Engine Oil Capacity –
Increased Level –
New Dipstick

MODEL
2000 MY-ON XK8 Range
2000 MY-ON V8 XJ Series
VIN
A00367-ON
F00464-ON

ILLUSTRATION 1

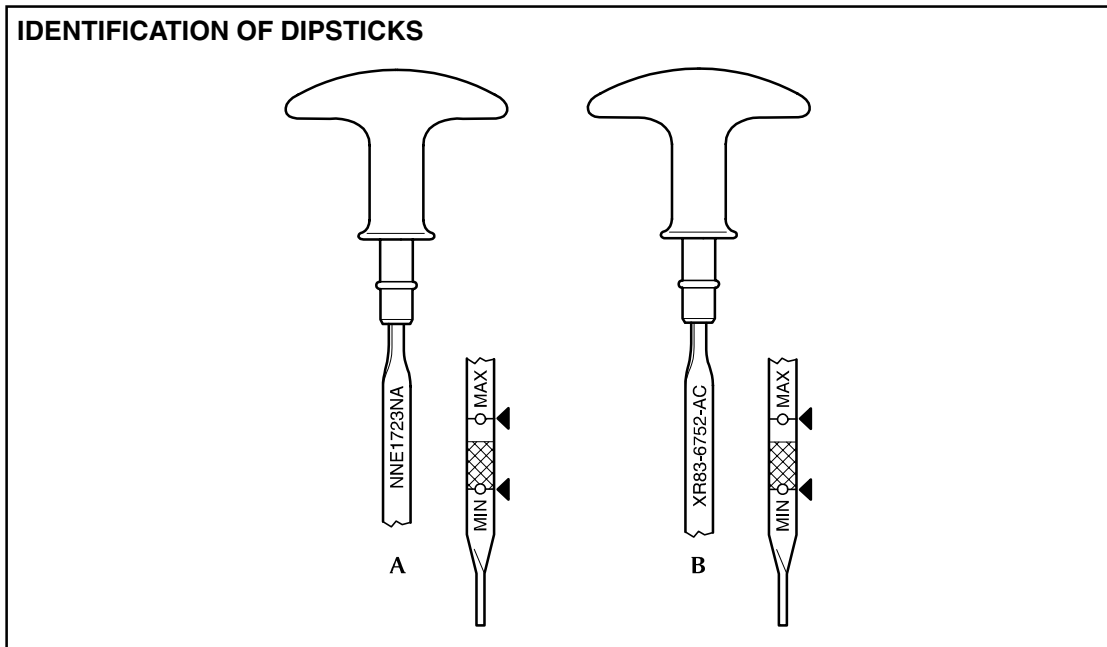
As a running change in production, introduced early in 2000 Model Year XK8 and V8 XJ Series vehicles, the engine oil fill has been increased by 1.0 liter from the VINs listed above. This has been achieved by installing a revised dipstick, part no. XR8 2806.

Pre VINs listed above: Illustration A - NNE 1723NA

From above VINs: Illustration B - XR83-6752-AC

By Production Part Number stamped near the handle.
